Project	IEEE 802.16 Broadband Wireless Access Working Group < http://ieee802.org/16 >	
Title	Consecutive Transmission of Bandwidth Request Indicators	
Date Submitted	2008-09-07	
Source(s)	Masato Okuda and Yanling Lu Fujitsu	E-mail: okuda@jp.fujitsu.com * http://standards.ieee.org/faqs/affiliationFAQ.html >
Re:	SDD Session 56 Cleanup: BW request channel; in response to the IEEE 802.16m-08/033, Call for Contributions and Comments on Project 802.16m System Description Document (SDD)"	
Abstract	To propose a bandwidth request method to reduce latency.	
Purpose	To propose a bandwidth request method to be adopted to the 802.16m SDD	
Notice	<i>This document does not represent the agreed views of the IEEE 802.16 Working Group or any of its subgroups. It represents only the views of the participants listed in the "Source(s)" field above. It is offered as a basis for discussion. It is not binding on the contributor(s), who reserve(s) the right to add, amend or withdraw material contained herein.</i>

Consecutive Transmission of Bandwidth Request Indicators

Masato Okuda and Yanling Lu
Fujitsu

Figure 1: Example of Bandwidth Request/Grant procedures

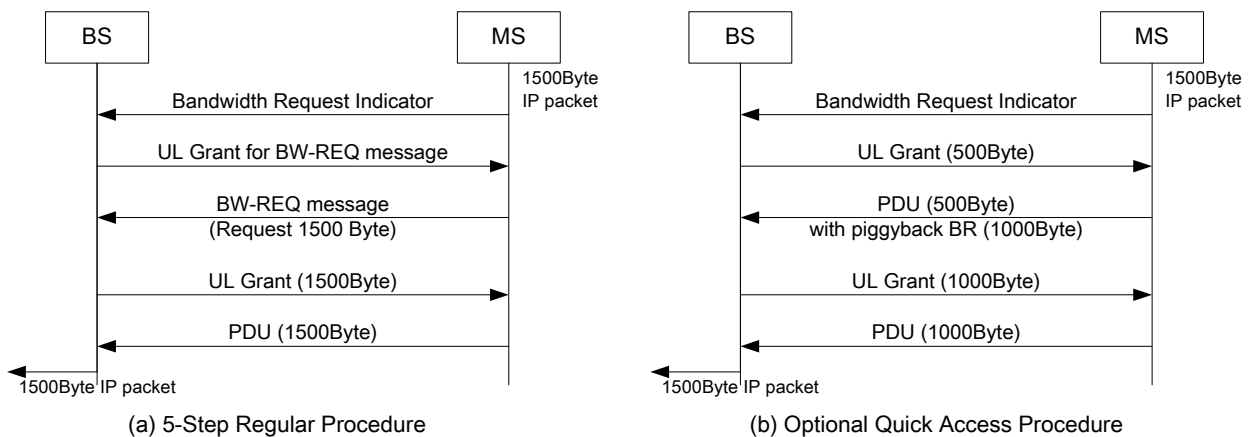
The figure 1 shows an example of the 5-step regular procedure (left) and the optional quick access procedure (right). As shown in the figure, the optional quick access procedure may not shorten transmission latency from SDU (IP packet) transmission point of view. According to the SRD, data latency should be considered at the IP layer. So, the optional quick access procedure is not enough to meet the requirement.

Figure 2: The proposed Bandwidth Request/Grant Procedure

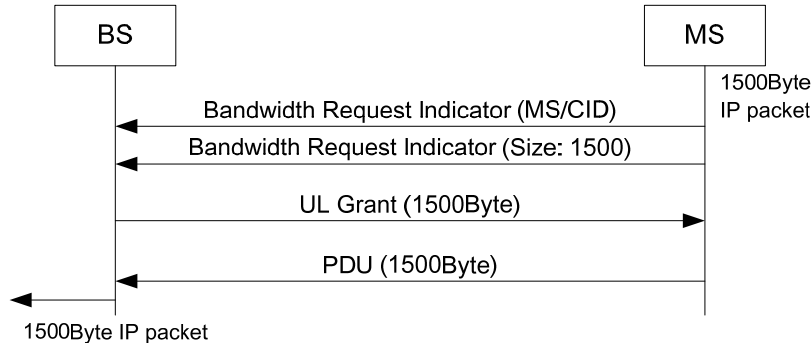
The figure 2 shows the proposed bandwidth request/grant procedure.

MS sends two consecutive bandwidth request indicator to the BS, the first indicator represents MS/ Flow ID and the second one represents the bandwidth request size.

Figure 3: Two consecutive transmission

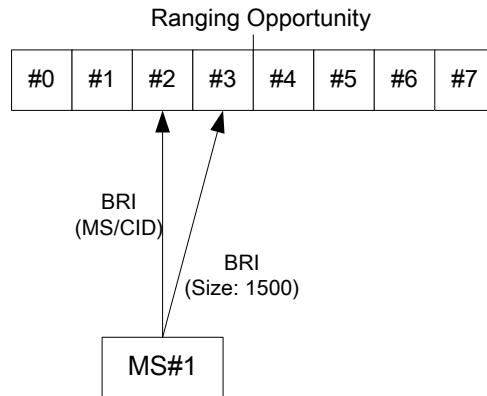
Figure 3 illustrates the consecutive transmission of two bandwidth request indicators. After choosing two consecutive ranging opportunities, MS sends the bandwidth request indicator containing MS/Flow ID information on the first ranging opportunity and the one containing the bandwidth request size on the second ranging opportunity.

When BS detects the consecutive bandwidth request indicators, it shall treat them as one bandwidth request. MS shall not send a bandwidth request indicator containing the bandwidth request size information as a single bandwidth request indicator. The bandwidth request indicator containing the bandwidth request size shall always follow the one containing MS/Flow ID information.
